Robert Steed
Surface Water Ecologist
Water Quality Division
DEQ Coeur d'Alene Regional Office
2110 Ironwood Parkway
Coeur d'Alene, Idaho 83814

RE: Comments on Draft §401 Certification for Post Falls Dam

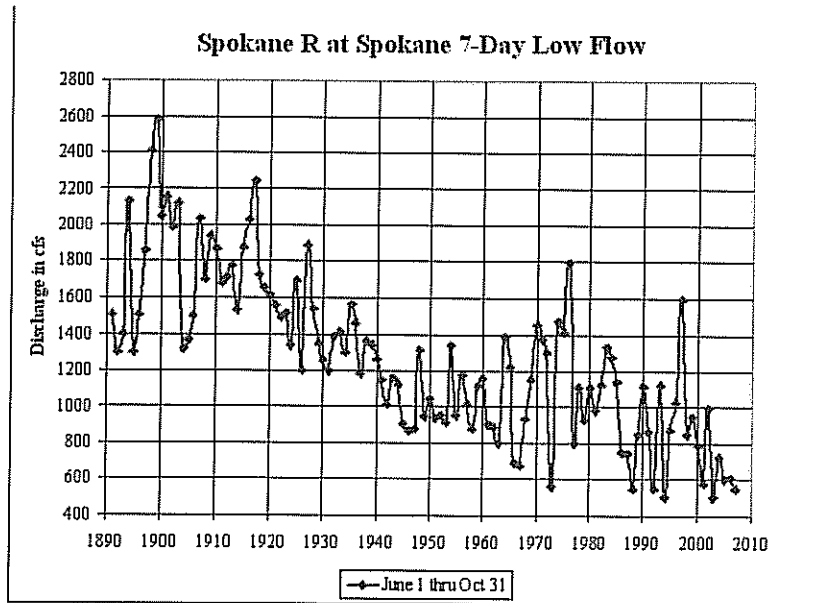
The Watershed Plan provided a detailed analysis of the current water quantity conditions in the Spokane River, as well as providing recommendation for flows protective of resources in the river. The Watershed Plan identified the trend of decreased flows in the Spokane River, as illustrated by the figure below, caused in part by operations of the Post Falls dam and the corresponding need to address the decreasing flows to protect Spokane River fisheries.
